PLANNING COMMISSION

**ISD #15 DISTRICT OFFICE BUILDING
4115 AMBASSADOR BLVD.**

December 20, 2017

City of St. Francis Planning Department
PUD Report

LANDSCAPE PLAN

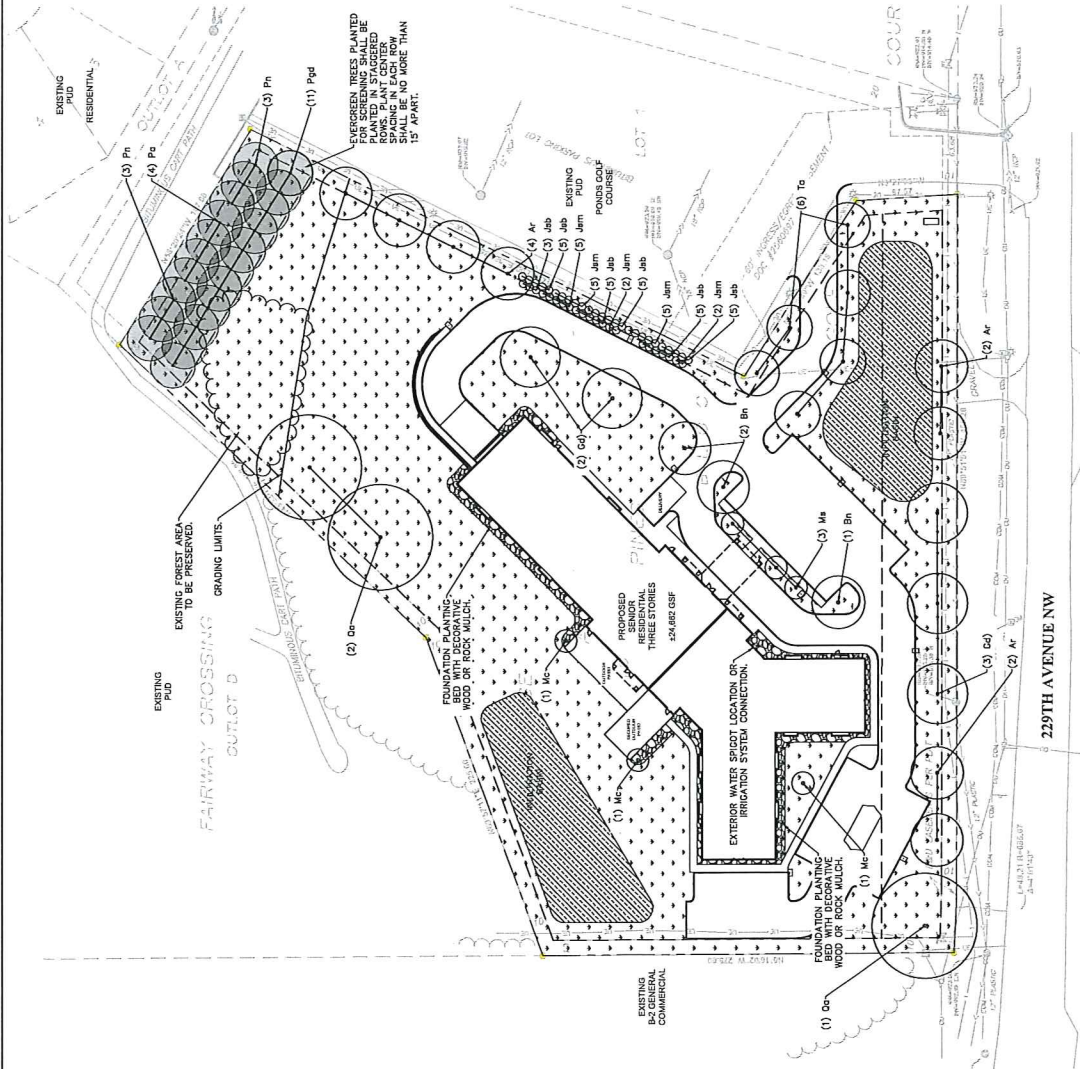
4. The proposed landscape plan shall be revised to comply with the City's tree caliper requirements.
5. Trees to be preserved shall be identified, and tree preservation techniques (including protective fencing) shall be installed prior to grading.

Project # 5002-0001
Drawn by JPA
Issue Date 2017-10-19
Issue # 1
Sheet # C-103
Sheet Title SITE PLAN

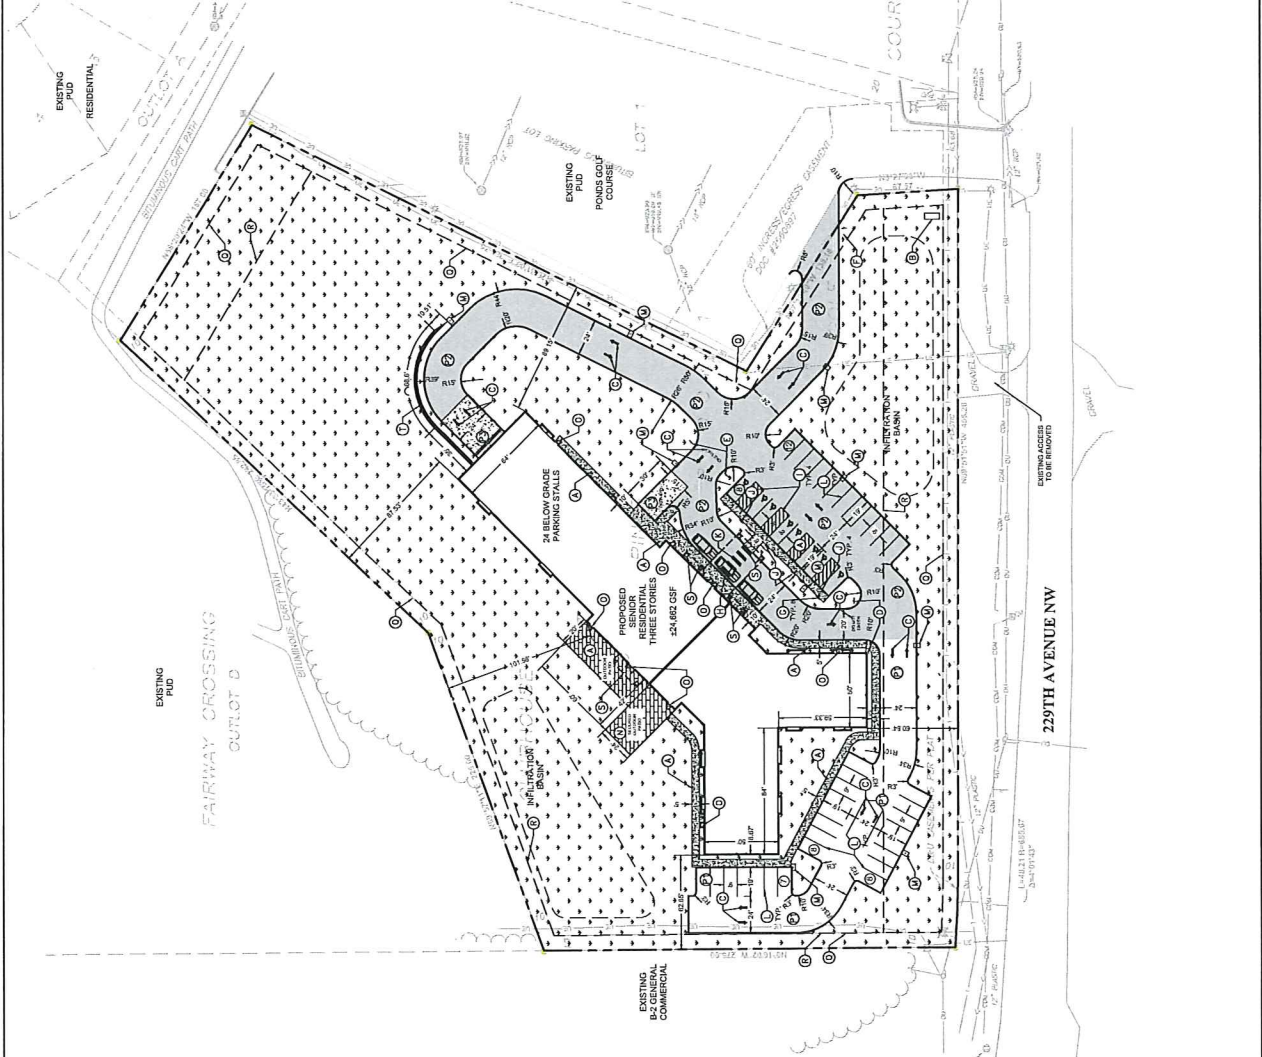
13. The site plan shall include an access driveway to the rear of the building for fire-safety purposes as directed by the City Fire Marshall.
 14. A trail easement will be supplied along 229th Ave. as previously proposed in the draft 2015 development agreement.
